W 49TH STREET OFFICE
1306, 1304 & 1210 W. 49TH ST., AUSTIN, TX 78756

SITE PLAN

SITE PLAN APPROVAL SHEET 6 OF 16
FILE NUMBER: SPC-2017-0339A APPLICATION DATE: 142 ON
CHAPTER 25-5 OF THE CITY OF AUSTIN CODE
EXPIRATION DATE (25-5-81, LDC) CASE MANAGER CLARISSA E. DAVIS
PROJECT EXPIRATION DATE (ORD #970905-A) DWP2 DDZ

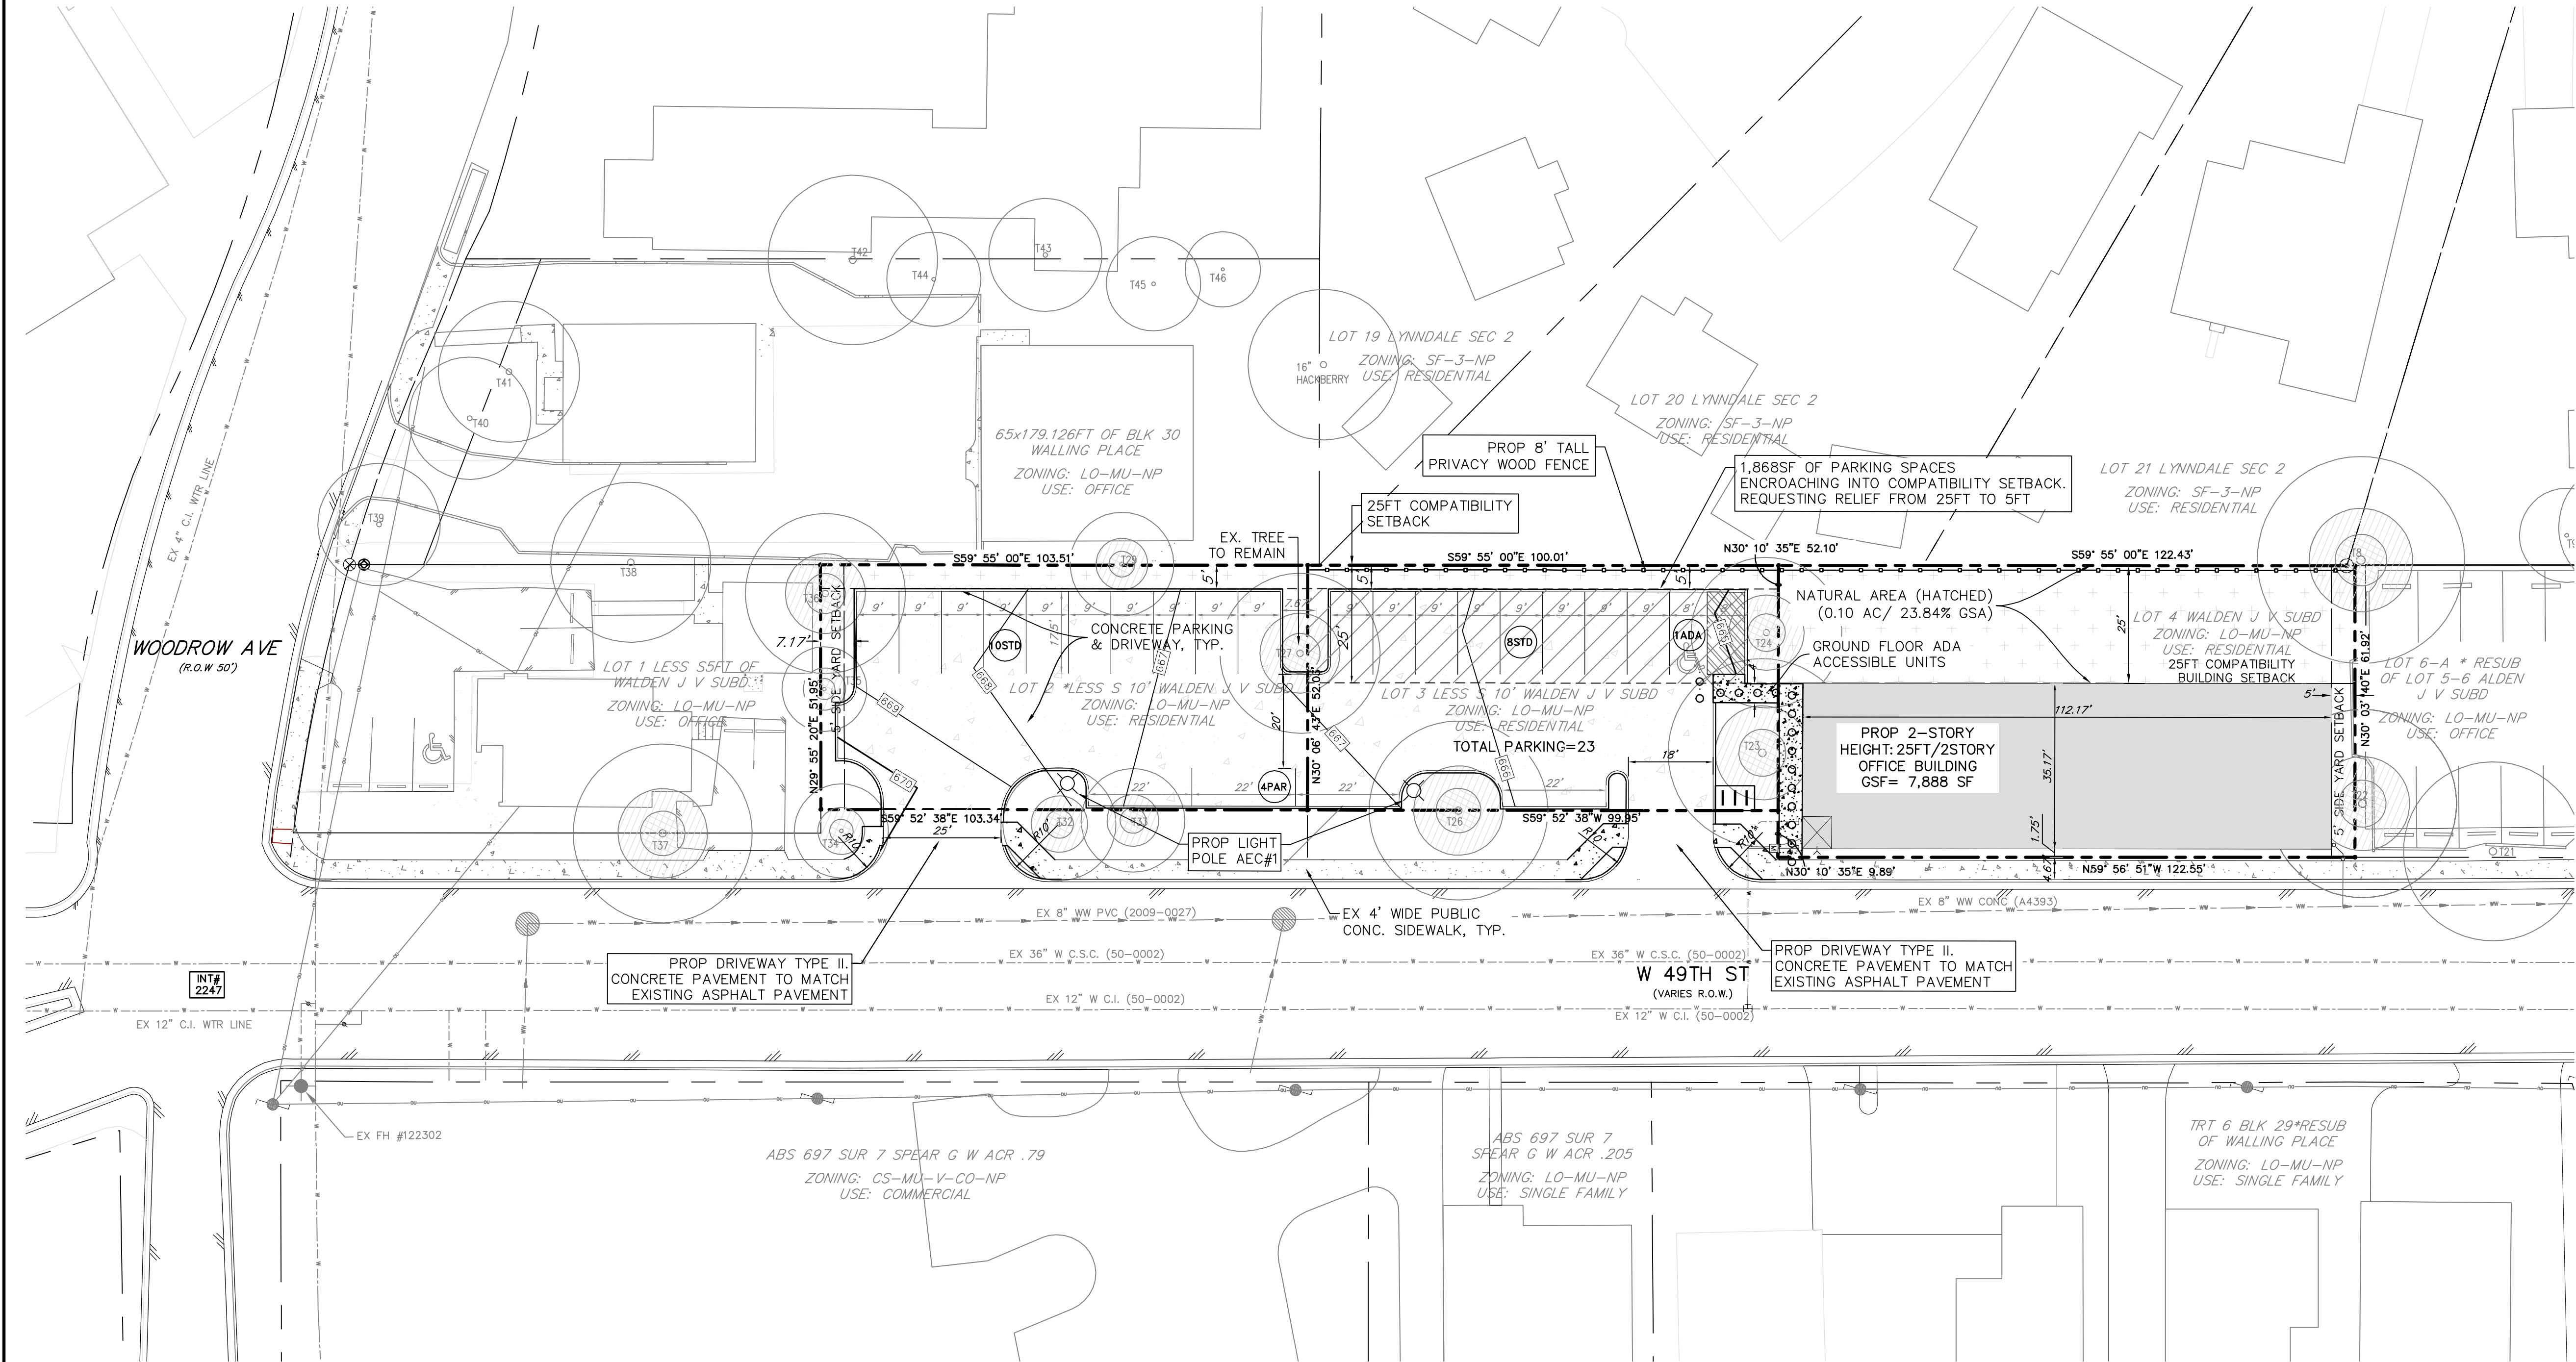
Staff is supportive of these conditions as they do not conflict with the code. The parking requirements will still be met with the reduction of 1 space, and an 8 ft. fence is allowed per 25-2-899(G)1 between a residential and commercial site. Thanks!
